TRUCK TANK FUEL HEAVY MC3 (MACK)
FITTING OF CLASS 3 FLAMMABLE LIQUID SIGN

MODIFICATION INSTRUCTION

Issue of this instruction is authorized by Army Office PCA 154/84

FIG 1 - LOCATION OF HOLES FOR FLAMMABLE LIQUID SIGN HOLDER AND ARN PLATE ON TRUCK TANK FUEL, HEAVY, MC3 (MACK)

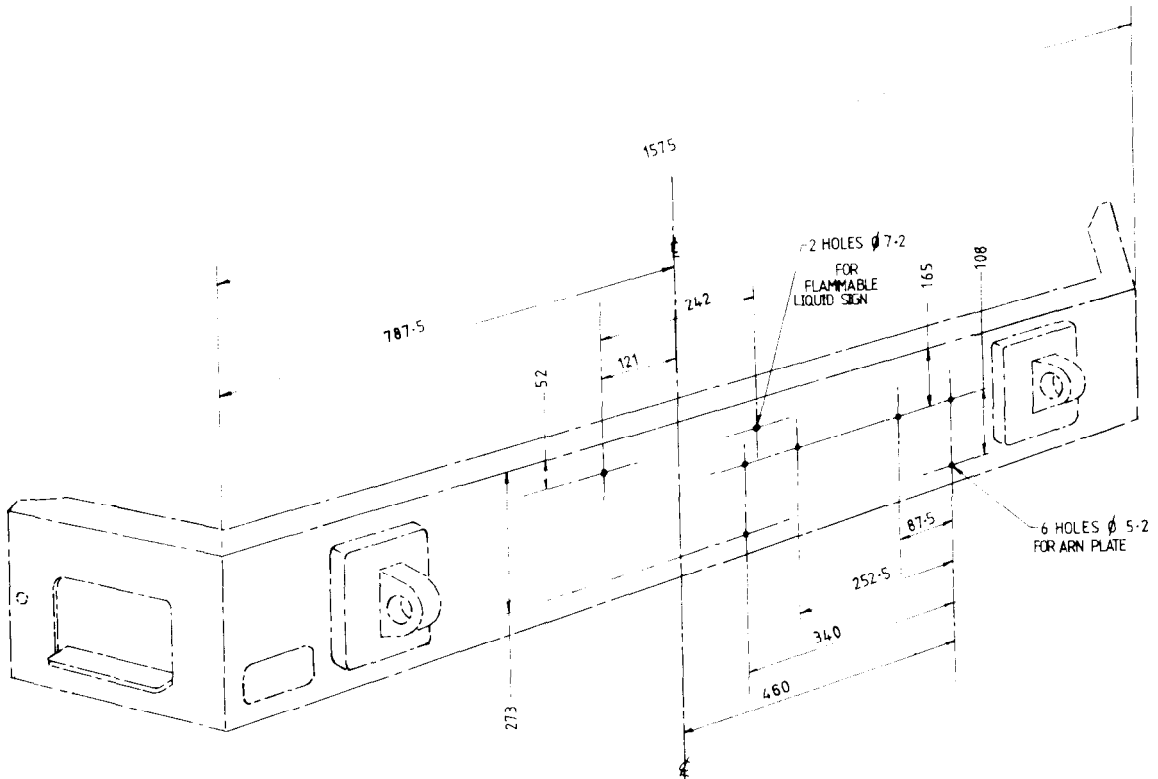
- a. Ensure the vehicle complies with Ref A.
- b. Drill heads of the existing pop rivets retaining the vehicle ARN plate and remove the plate from the front bumper bar.
- c. Mark the new hole centres for remounting the ARN plate to the bumper bar as indicated in Fig 1.
- d. Drill the new holes for the ARN plate using a 13/64 inch drill.
- e. Refit the vehicle ARN plate to the bumper bar using item 4 in Table 2.
- f. Mark the hole centres for the flammable liquid sign holder as per Fig 1 and drill the holes using a 9/32 in drill.
- g. Using the 1/4 in UNF bolts, nuts and spring washers, (items 1 to 3 in Table 1) mount the sign holder to the bumper bar as shown in Fig 2 and insert the flammable liquid sign.
